**Department of Energy**  
Carlsbad Field Office  
P. O. Box 3090  
Carlsbad, New Mexico 88221  
FEB 17 2016

Subject: Class 1 Permit Modification Notifications to the Waste Isolation Pilot Plant  
Hazardous Waste Facility Permit Number: NM4890139088-TSDF

**Class 1 Permit Modification Notifications**

**Waste Isolation Pilot Plant  
Carlsbad, New Mexico**

**Figure F-1**  
Organizational Location of Training, Waste Handling, and Emergency Response Functions

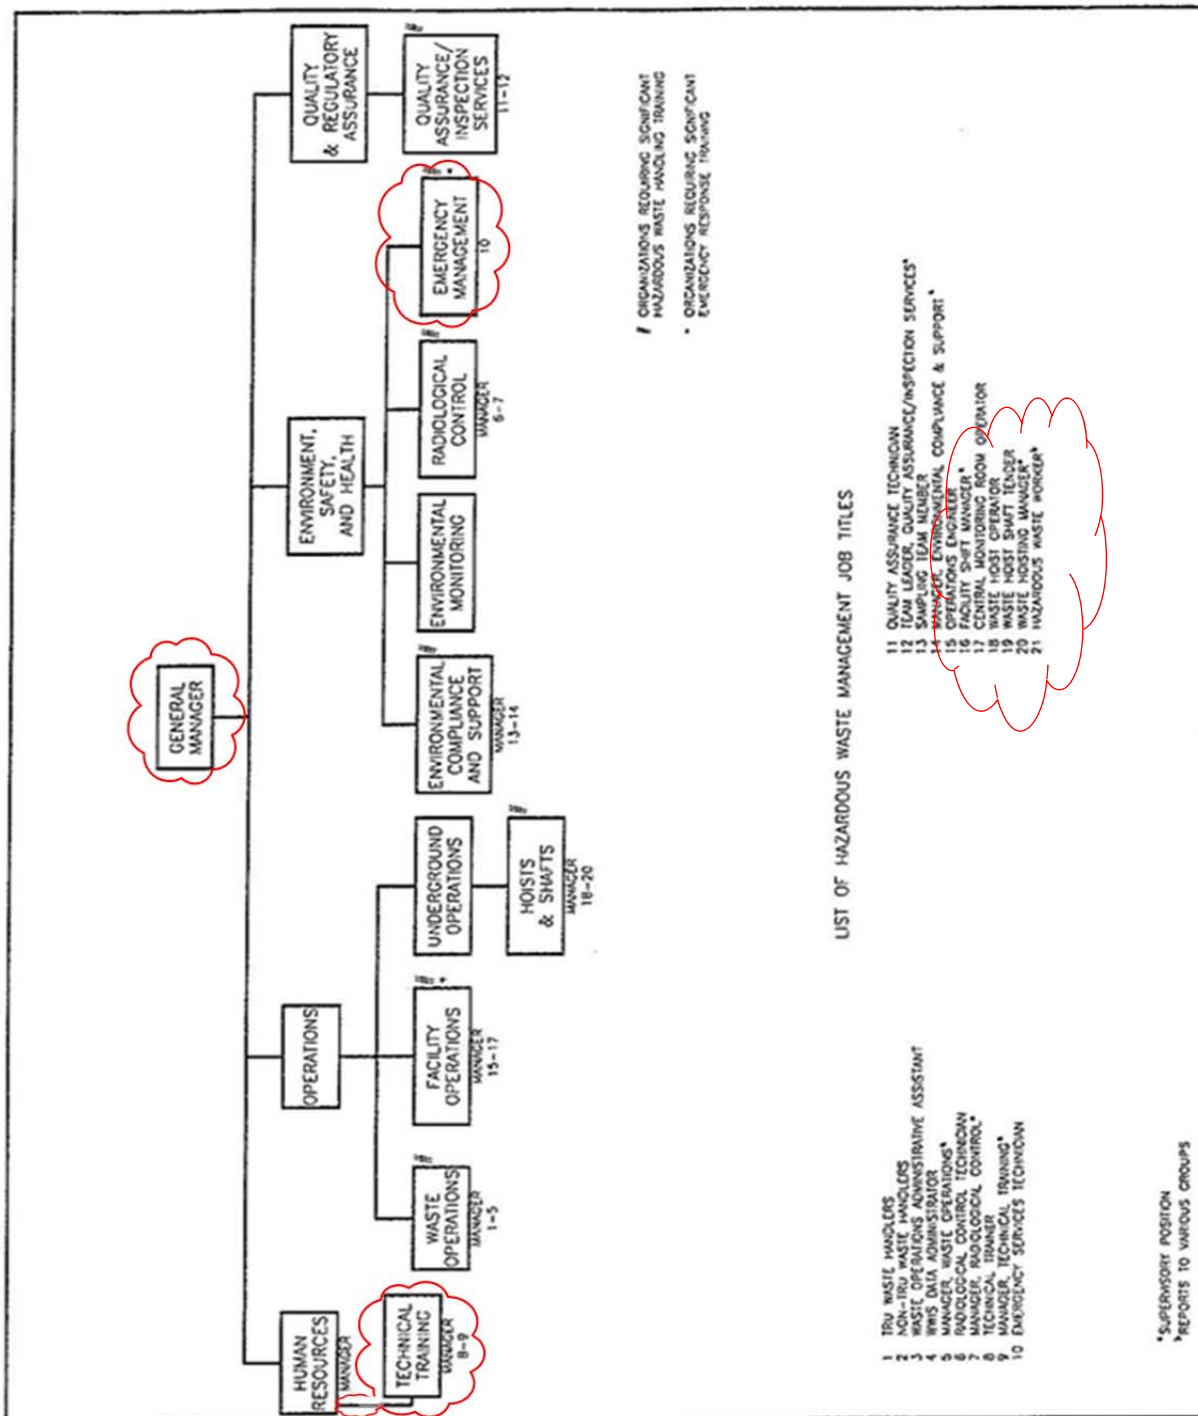
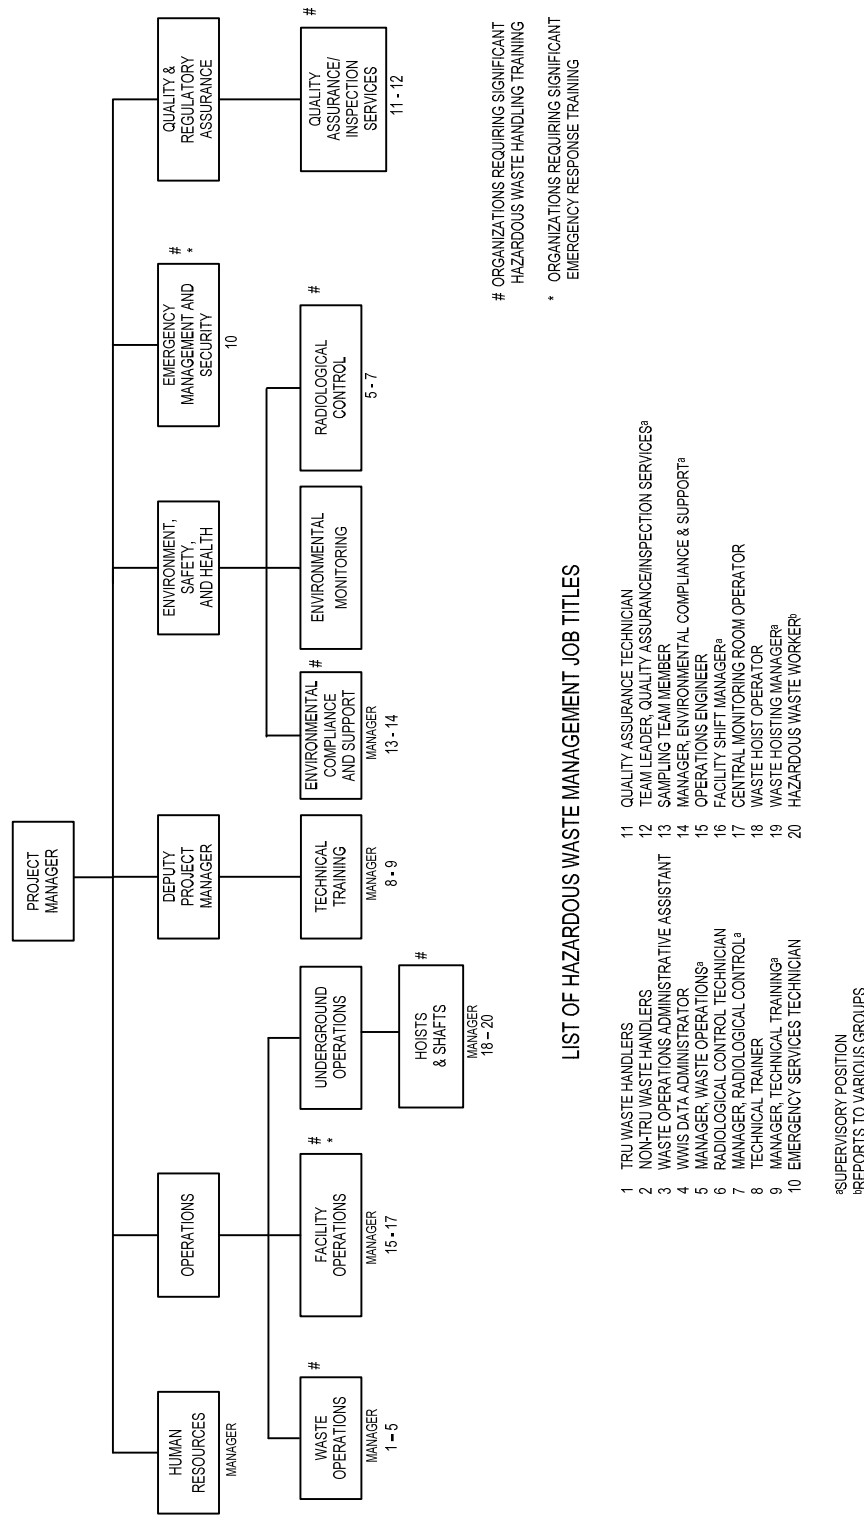
This modification revises Attachment F, Figure F-1, *Organizational Location of Training, Waste Handling, and Emergency Response Functions*, to change “General Manager” to “Project Manager” and to indicate that Technical Training is now reporting to the Deputy Project Manager. Attachment F, Figure F-1 is being revised to change “Emergency Management” to “Emergency Management and Security” and to indicate that this organization is now reporting to the Project Manager in lieu of Environment, Safety, and Health.

**Figure A2-9**  
**Underground Ventilation System Airflow**

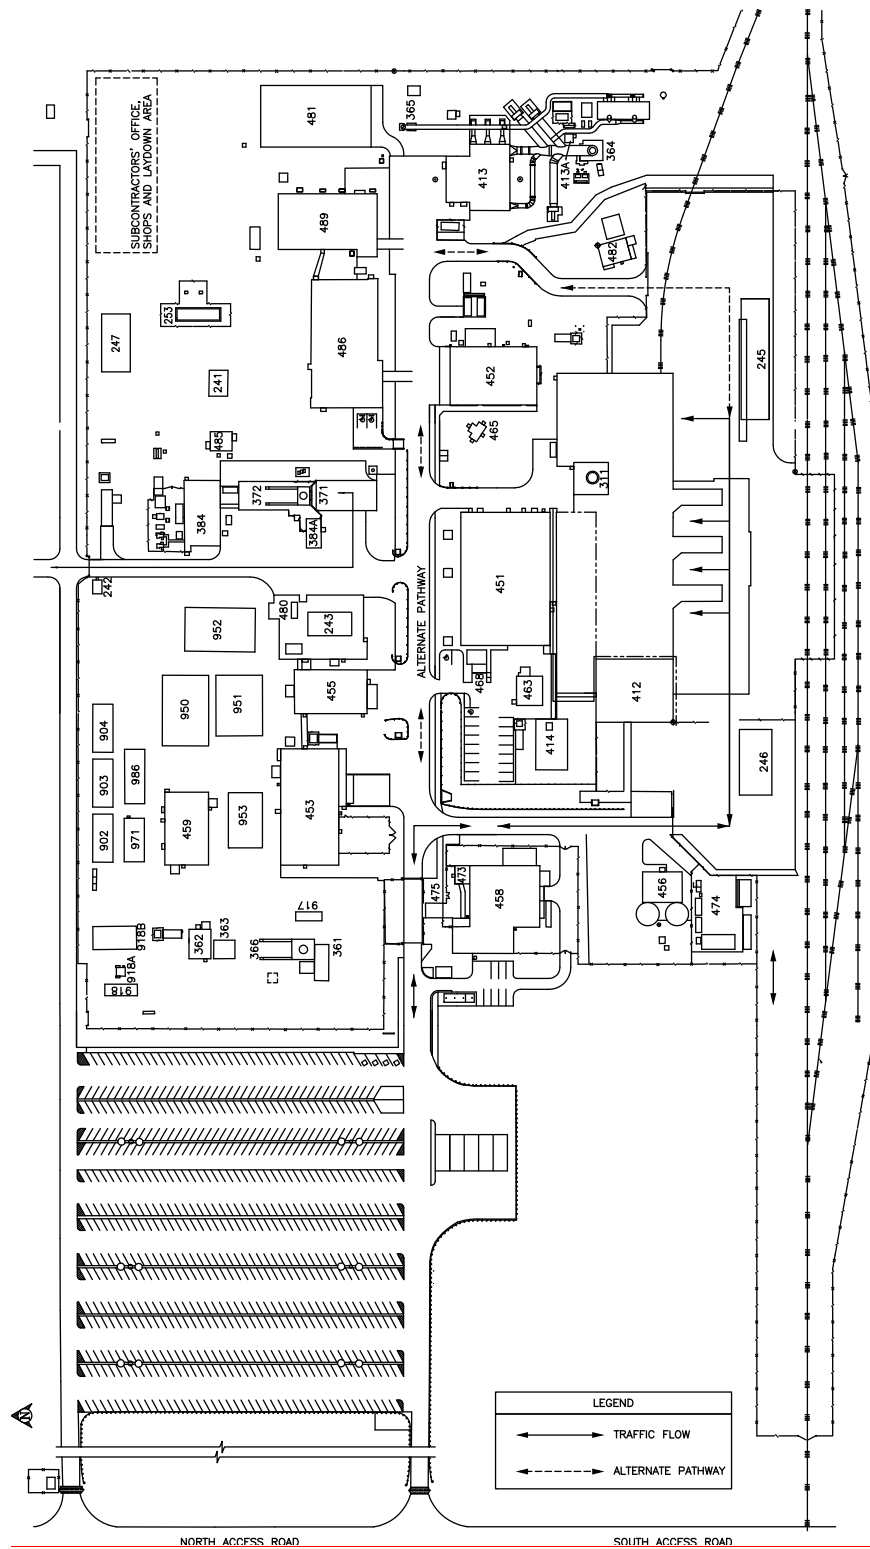
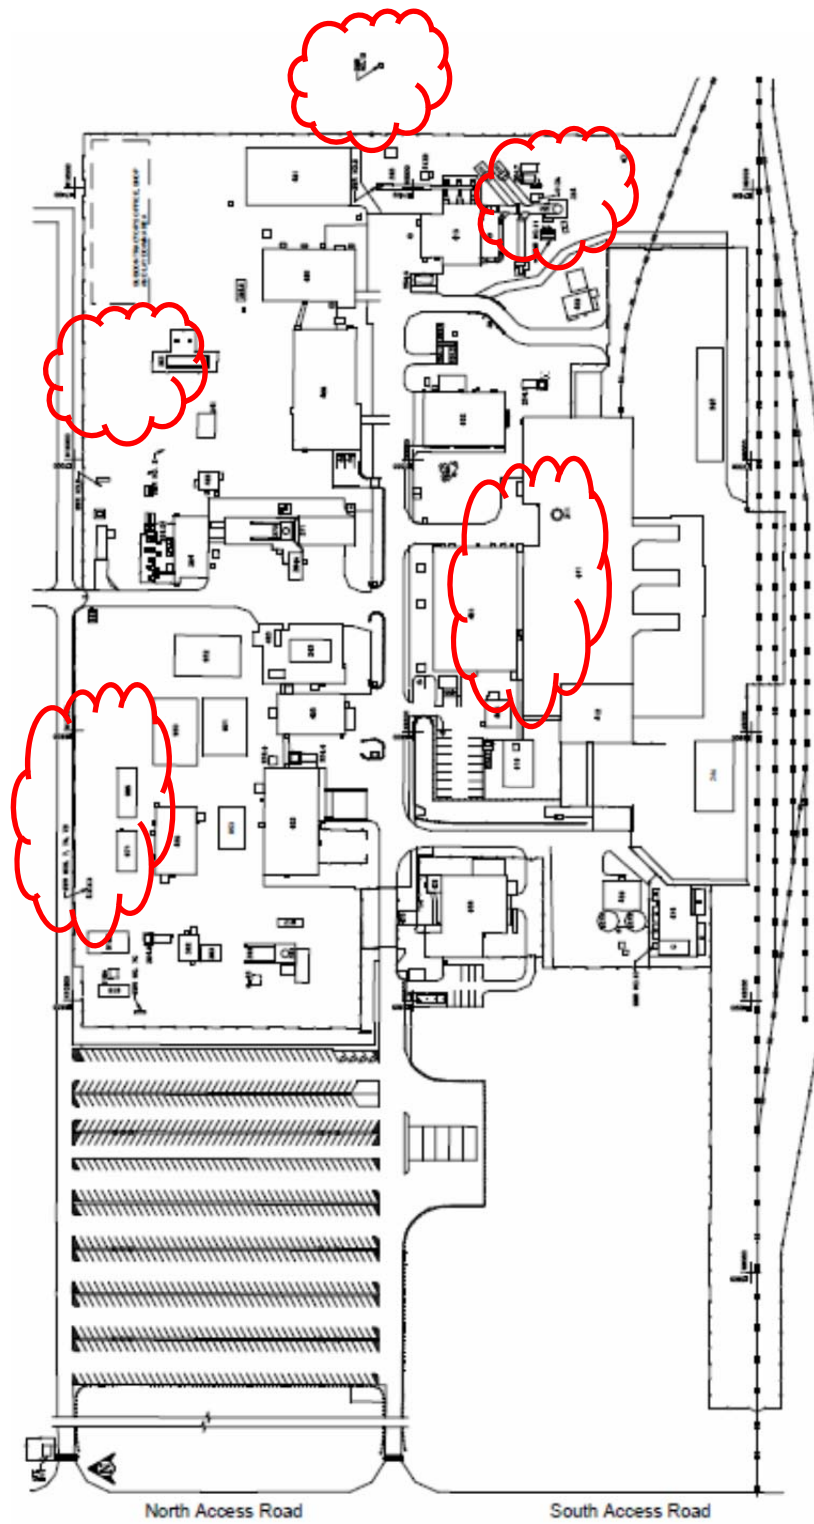
This modification updates descriptive language in the Permit sections, figures and tables listed below regarding the underground ventilation system to include the WIPP facility Interim Ventilation System (IVS):

- Attachment A2, Section A2-2a(3), *Subsurface Structures*
- Attachment A2, Figure A2-9, *Underground Ventilation System Airflow*
- Attachment A4, Figure A4-2, *WIPP Traffic Flow Diagram*
- Attachment D, Figure D-1, *WIPP Surface Structures*
- Attachment D, Figure D-1a, *Legend to Figure D-1*
- Attachment D, Figure D-6, *Fire-Water Distribution System*
- Attachment D, Figure D-8, *WIPP On-Site Assembly Areas and WIPP Staging Areas*
- Attachment O, Table O-1, *Ventilation Operating Modes and Associated Flow Rates*

**Figure D-1**  
**WIPP Surface Structures**

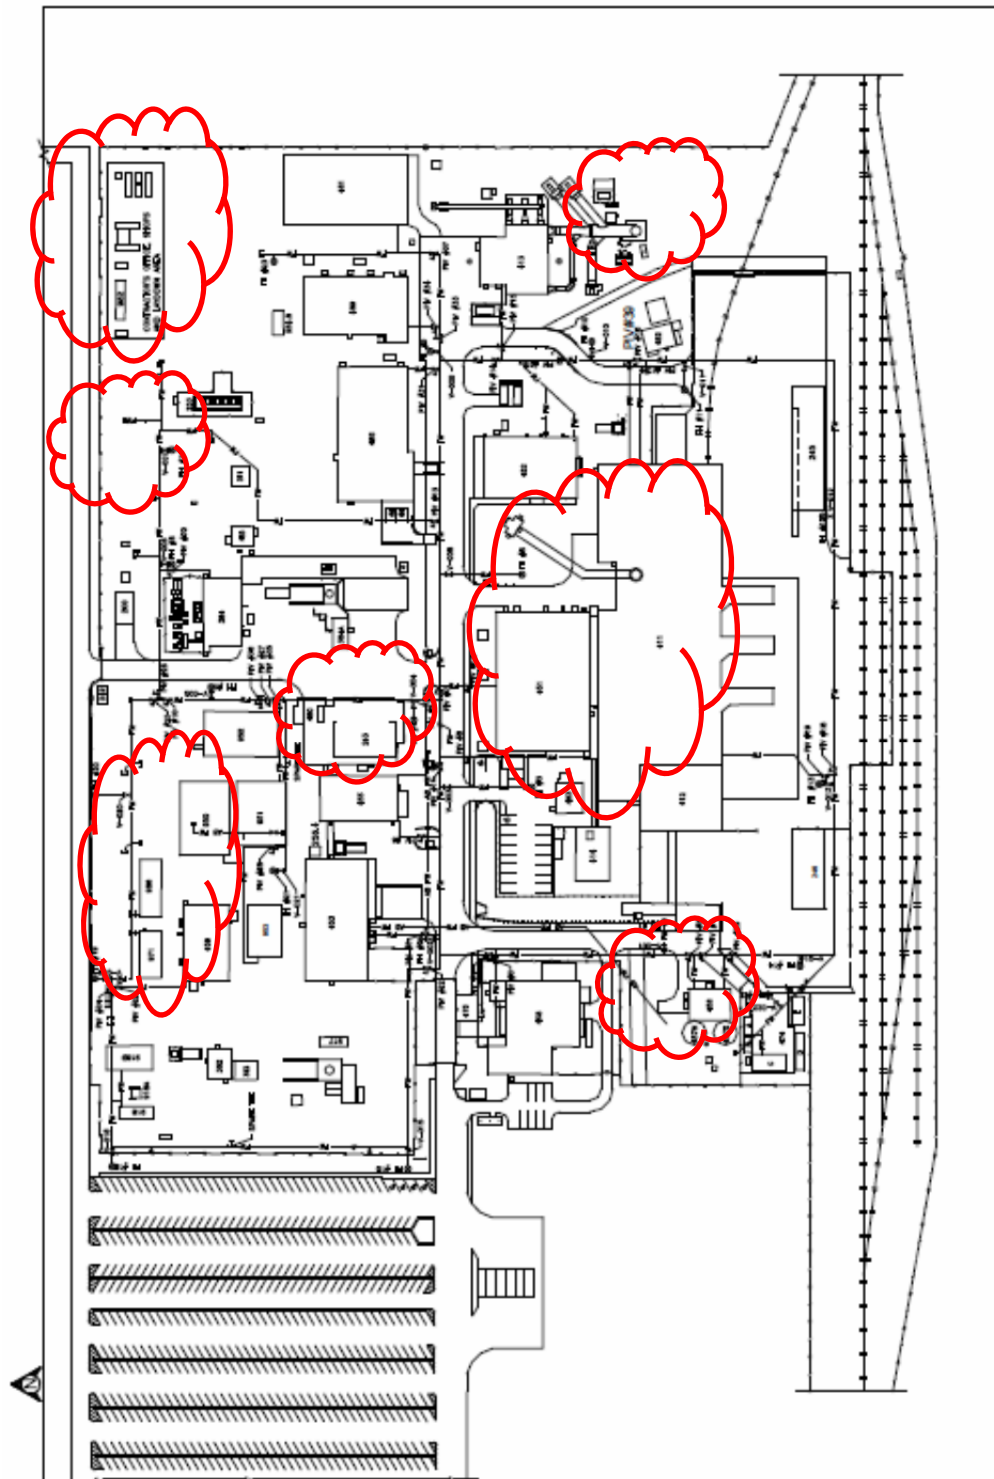
Editorial changes are also being made to the Permit text to correct some typographical errors and to clarify existing text. For example, a parenthetical is being added; “e.g.” is replacing “i.e.” in reference to availability of the main exhaust fans; “contaminants in the reduced exhaust flow” is being changed to “particulates” in reference to high efficiency particulate air (HEPA) filtration; and the Figures A2-9, A4-2, D-1, D-1a, D-6 and D-8 are being revised to include the new 900 series trailers, the north maintenance shop, and other additions and/or deletions of surface facilities. These changes to the figures are identified with “clouds” which indicate the additions and/or deletions of the surface facilities.
